**CERTIFICATE OF APPROPRIATENESS**

**Property:** 1810 Kane St, Lot 6, Block 443, Baker W R NSBB Subdivision. The property includes a historic 1,400 square foot, one-story wood frame single-family residence situated on a 5,000 square foot (50' x 100') interior lot.

**Proposal:** Alteration – Replace tapered porch columns with new tapered porch columns, replace soffit materials with a wood-grain composite material, and remove a porch header.

HPO File No. 150839

**PHOTO BEFORE WORK COMPLETED**

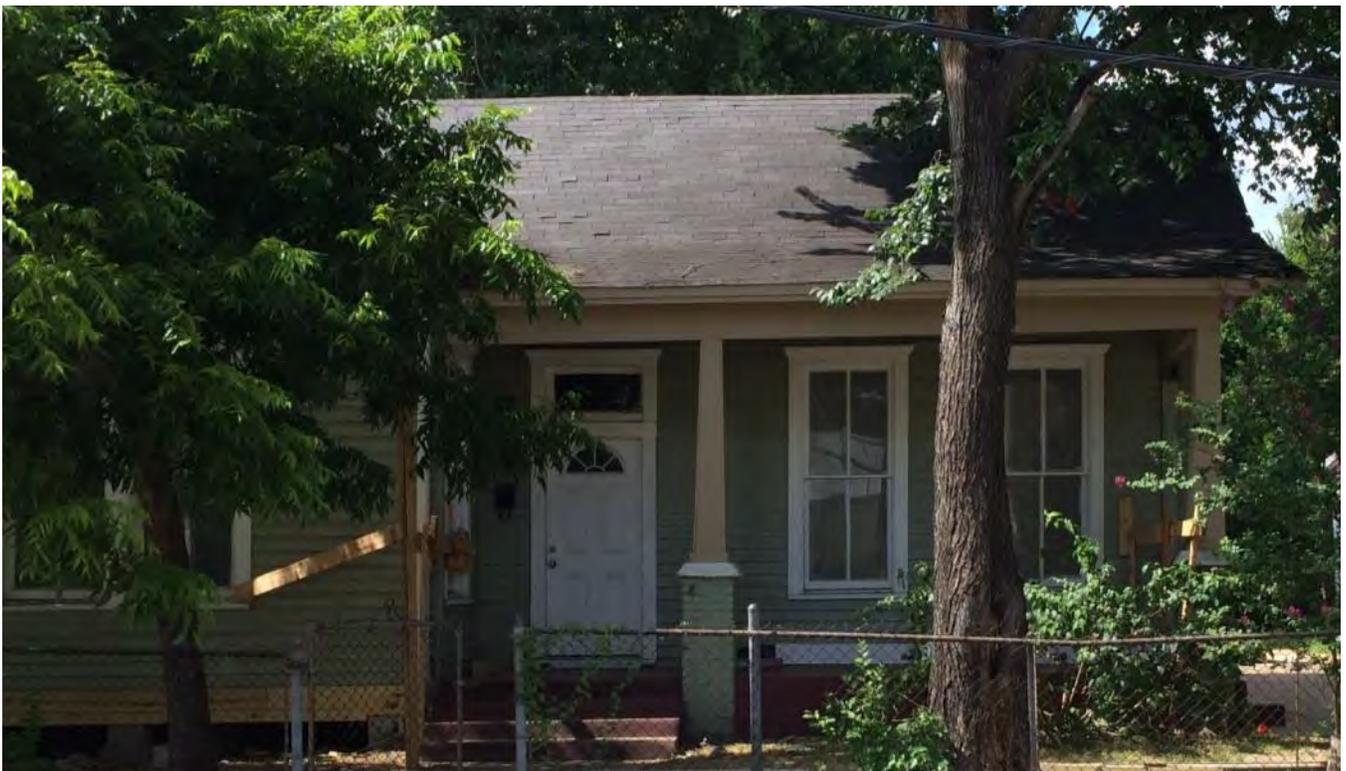
| <input type="checkbox"/>            | <input checked="" type="checkbox"/> | <input type="checkbox"/>            | (1)                  | The proposed activity must retain and preserve the historical character of the property;<br><i>The removal of the tapered columns and header results in the loss of historical character and the new tapered columns do not match what was removed. The installation of columns that match the engaged column will preserve the historical character of the property.</i>   |                            |  |
| <input type="checkbox"/>            | <input checked="" type="checkbox"/> | <input type="checkbox"/>            | (5)                  | The proposed activity must maintain or replicate distinctive stylistic exterior features or examples of skilled craftsmanship that characterize the building, structure, object or site;<br><i>The new tapered columns do not match the ones removed. The project would meet this criterion if new columns that match the engaged ones were installed.</i>  |                            |  |

**Front Elevation:** The elevation contained two brick piers with plywood tapered columns. The applicant removed a porch header and the tapered columns and installed thinner and taller composite board columns with a wood-grain finish.  
**(South)**

**Recommendation:** **Approval with conditions: Reinstall the missing header above the porch, install columns to match the existing engaged columns, and replace the wood-grain finish soffit material with smooth-finish or wood to match original.**
